# Access Compliance Report

## Public Rights-of-Way

### (Curb Ramps)

Intersection ID: 29158	Main Street: RIDGE_RD	Cross Street: HIGHLAND_PARK_DR	Location: N
ADA ID: 2B2F2AE782C0	Ramp Type: Perp	Initial Pass/Fail: Fail	Overall Compliance: No
			Severity Score: 21.25

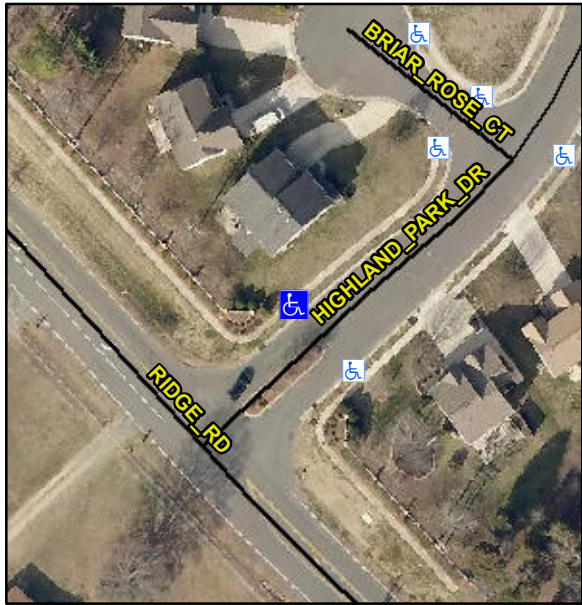
Codes/Mitigation Info/Possible Solution			Field Measurements/Component Compliance					
	Possible Solutions:		Compliance	Description	Data	Compliance	Description	Data
	Remove & Replace Entire Ramp.		N/A	Ramp Length (in)	49.0	No	Ramp Slope (%)	9.2
			No	Ramp Width (in)	47.5	Yes	Ramp XSlope (%)	1.9
			N/A	Flare Type LT	N/A	N/A	Flare Type RT	N/A
			N/A	Flare Slope LT (%)	N/A	N/A	Flare Slope RT (%)	N/A
			N/A	Flare Traversable LT?	N/A	N/A	Flare Traversable RT?	N/A
			N/A	Landing Length (in)	N/A	N/A	DWS Provided?	N/A
			N/A	Landing Width (in)	N/A	N/A	DWS Contrast?	N/A
			N/A	Landing Slope (%)	N/A	N/A	DWS Length (in)	N/A
			N/A	Landing X Slope (%)	N/A	N/A	DWS Full Width?	N/A
Surveyor Notes:			N/A	Landing Curb? (Y/N)	N/A	N/A	DWS Offset (in)	N/A
N/A			N/A	Shared Landing?	N/A			
PROW/ADA:			N/A	Gutter Ponding?	N/A	N/A	Gutter Slope (%)	N/A
R304.5.1, R304.2.2			N/A	Gutter Lip Ht (in)	N/A	N/A	Gutter X Slope (%)	N/A
			N/A	Painted X Walk1?	No	N/A	Painted X Walk2?	N/A

X Walk 1 Direction	To SE		X Walk 2 Direction	N/A
			N/A	X Walk 1 Width (in)	N/A	N/A	X Walk 2 Width (in)	N/A
				X Walk 1 Slope (%)	2.9		X Walk 2 Slope (%)	N/A
				X Walk 1 X Slope (%)	1.2		X Walk 2 X Slope (%)	N/A
			N/A	Ramp inside XWalk1?	N/A	N/A	Ramp inside XWalk2?	N/A
				Road Slope (%)	N/A	N/A	Clear Space?	N/A
				Road X Slope (%)	N/A	N/A	Clear Space to XWalk (in)	N/A
			N/A	Any Obstructions?	N/A	N/A	Storm Grate/Utility Hazard?	N/A
				Obstruction Type			Storm Grate/Utility Type	
					N/A			N/A
						Yes	Surface Condition? (G/P)	Good
					</
